**Rantoul Village Board of Trustees  
Regular Study Session  
February 5, 2008**

CHANGE ORDER NO. 14

## CHANGE ORDER #14 - DESCRIPTION

### **Change Item 14-1: Excessive Groundwater Leakage into the Softener Room Excavation**

Drawing No.: 100-S-1  
 Sheet No.: 37

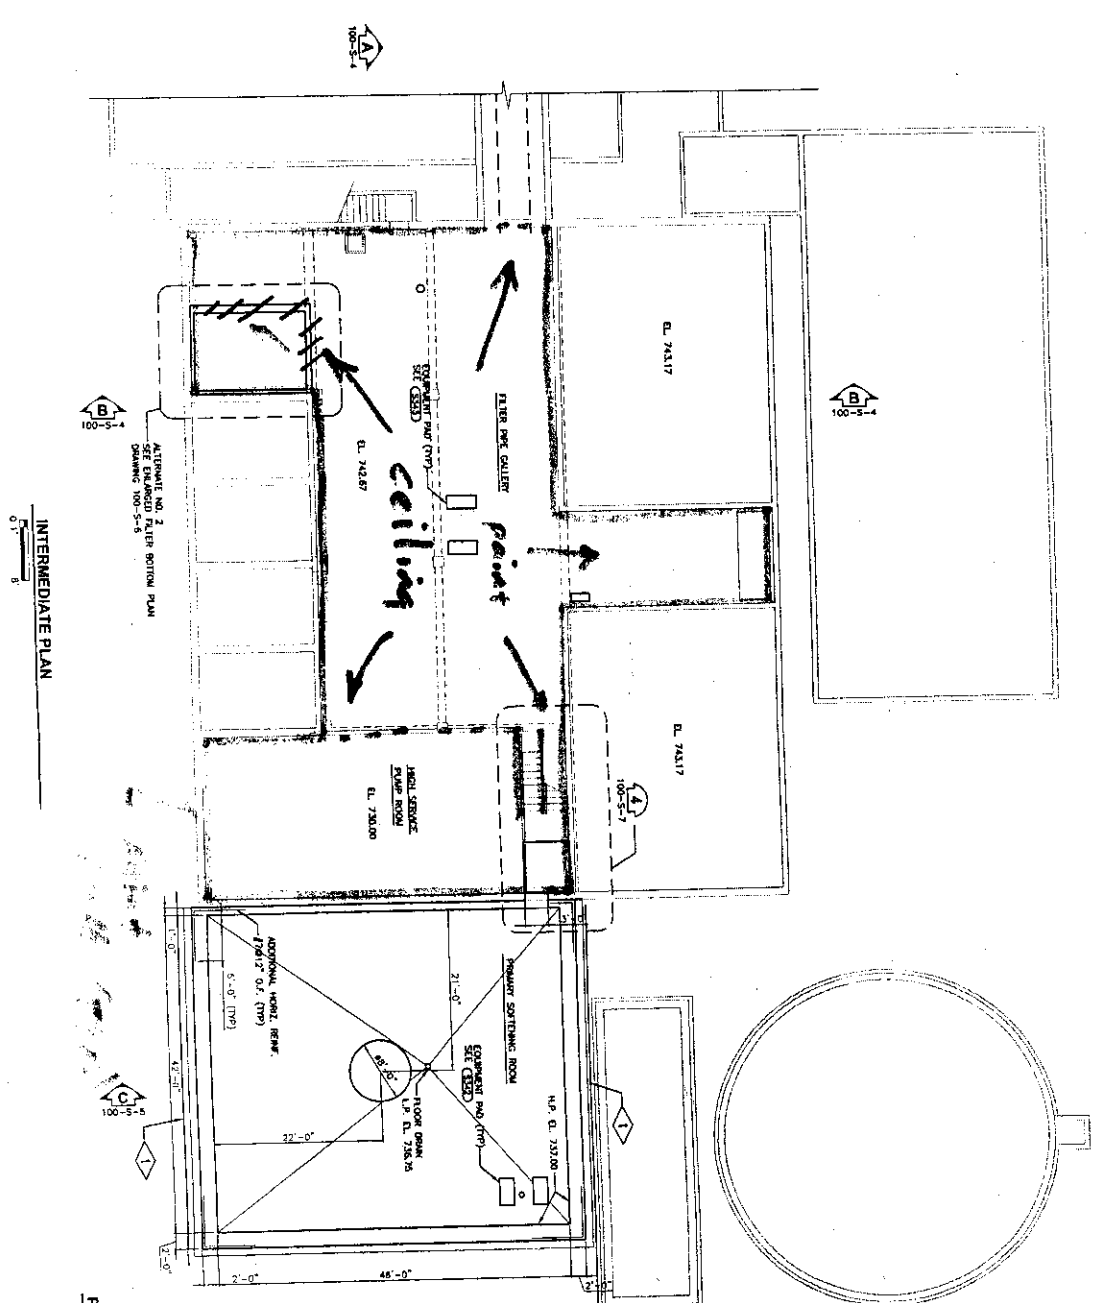
2.) Paint walls and ceiling of the existing East Plant to the extent shown on sheet 37 as per section #09960.

Paint the Walls and Ceilings of the existing East Plant to the extent shown on sheet 37 as per Section #09960.

CHRIS, 1. PAINT THE WALLS AND CEILINGS OF THE EXISTING EAST PLANT TO THE EXTENT SHOWN ON SHEET 37 AS PER SECTION #09960  
CHRIS:

<p>VILLAGE OF RANTOUL EAST WATER TREATMENT PLANT RECONSTRUCTION RANTOUL, ILLINOIS</p> <p style="font-size: 24pt; font-weight: bold;">40</p> <p style="text-align: center;">EAST WATER TREATMENT PLANT PLAN</p>	
Sheet No. 46	Drawing No. 100-M-2

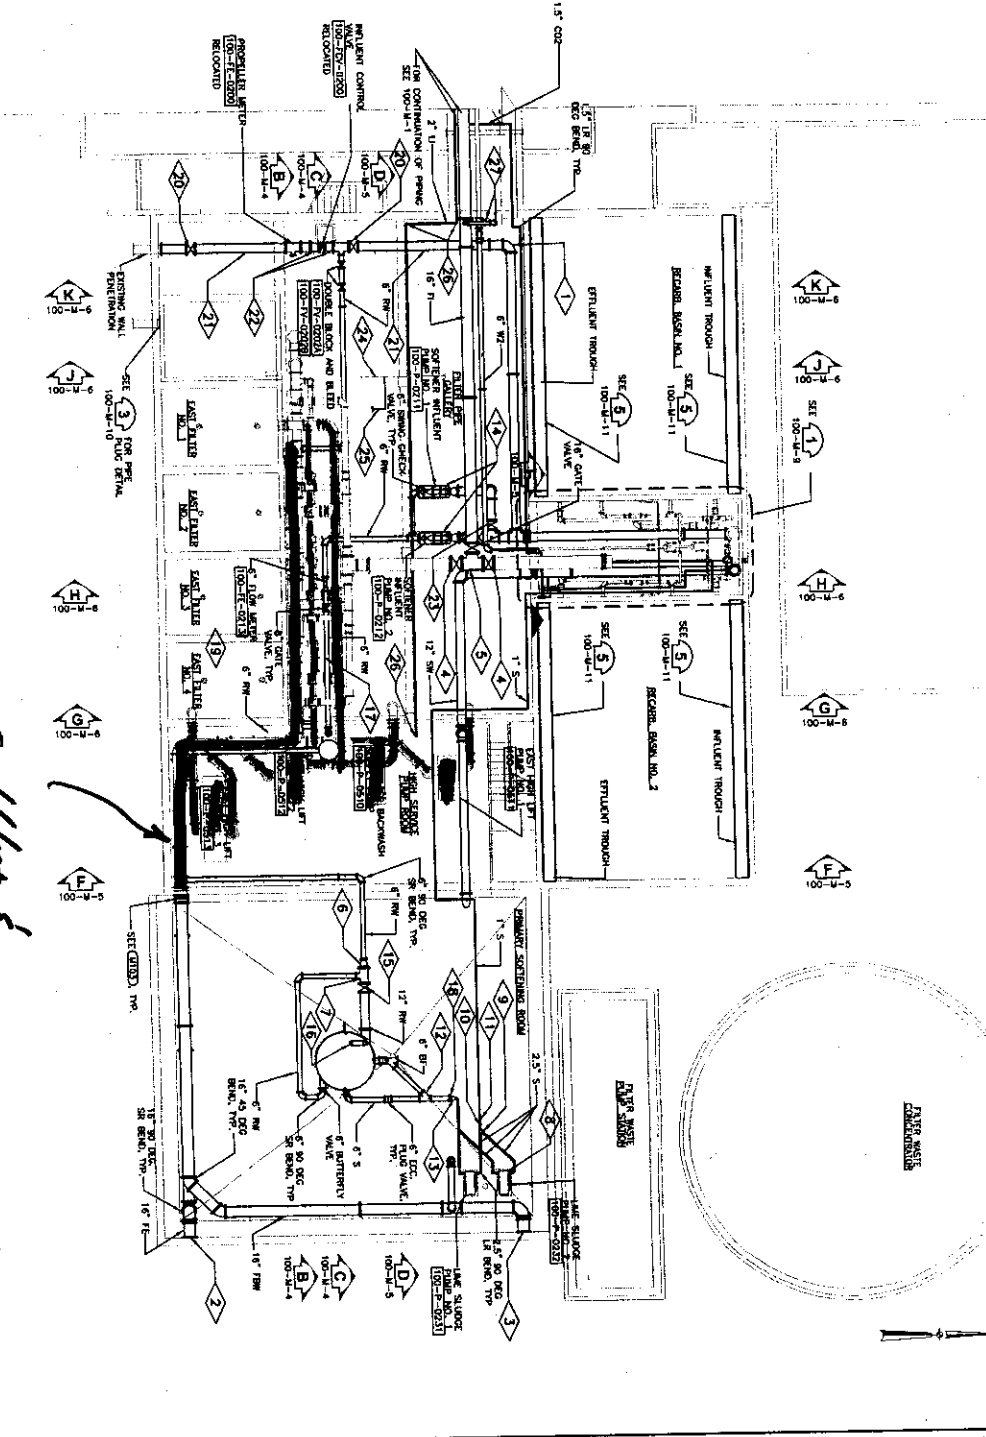
1.) Paint the Un-Insulated existing piping in the existing East Plant to the extent shown on sheet 46 per Section #00960

Paint the Un-Insulated existing piping in the existing East Plant to the extent shown on sheet 46 as per Section #09960.

2. PAINT THE UNINSULATED EXISTING PIPING IN THE EXISTING EAST PLANT AS SHOWN ON SHEET 46 PER SSECTION #09960
